Highway 1 Auxiliary Lanes and Bus-on-Shoulder Improvements -- Freedom Boulevard to State Park Drive -- and Coastal Rail Trail Segment 12 Project

Figure 1-3a. Project Components, Sheet 1 of 3

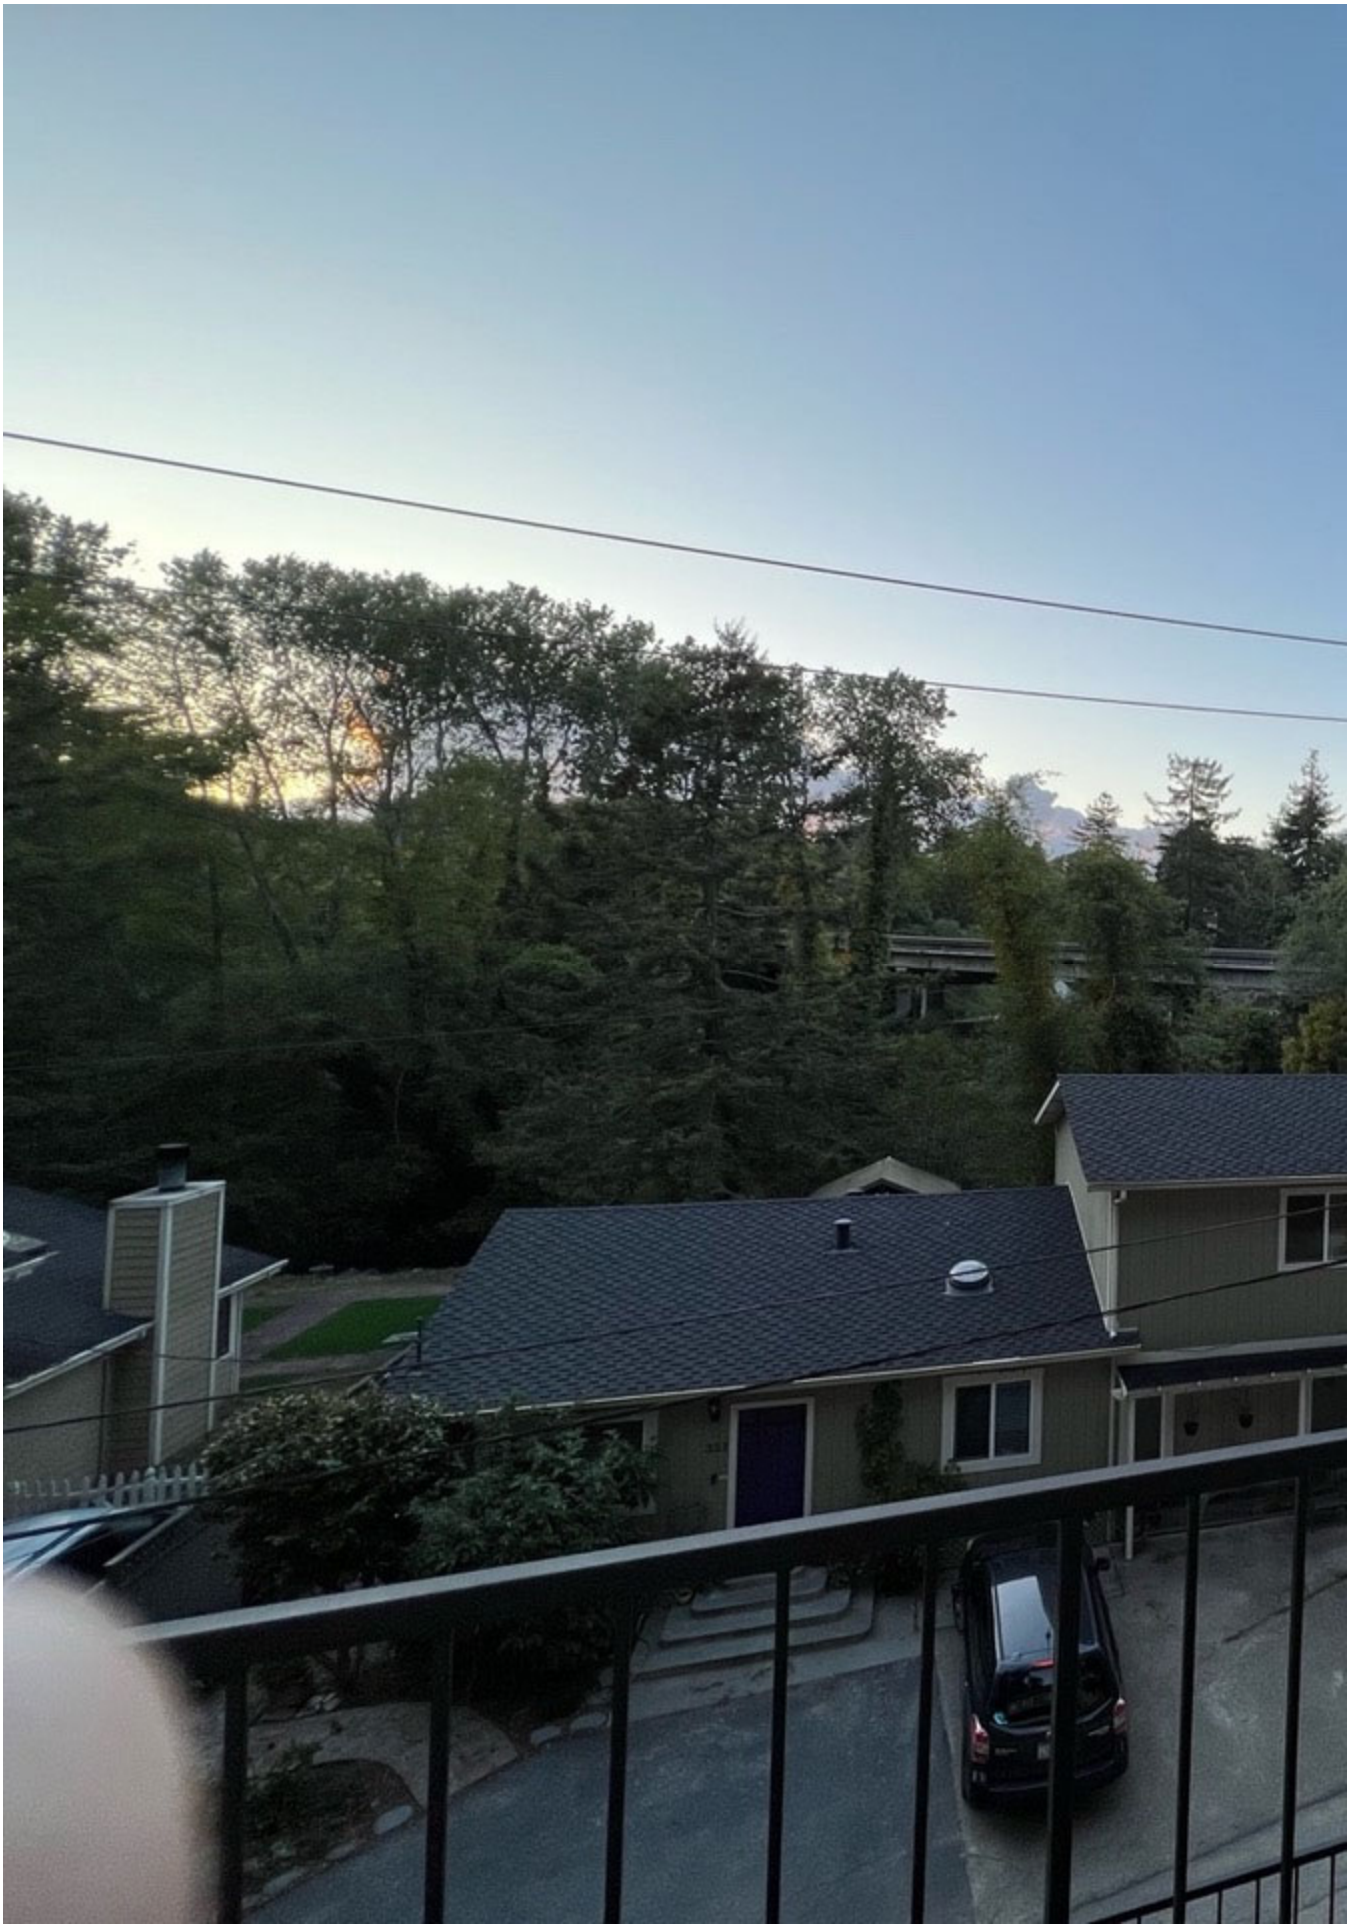
Comment #7: In Chapter 1 Proposed Project, figure 1-3a states soundwall (S89 – indicated in purple) will be installed as part of the project. There are so many discrepancies in all the different reports. The information residents are being told, vs documentation on the website. None of it matches. The

end of Moosehead Drive, which was included during the preparation of the Visual Impact Assessment that is no longer a part of the proposed project. Although this soundwall is no longer a part of the proposed project, the simulation for View 2 still mostly conveys how visual conditions would appear after vegetation removal and trimming, grading, and installation of the retaining walls occur. Since preparation of the Visual Impact Assessment, the project design continues to be refined, and the soundwalls shown in Draft Environmental Impact Report/Environmental Assessment Figure 1-3b are the most current.
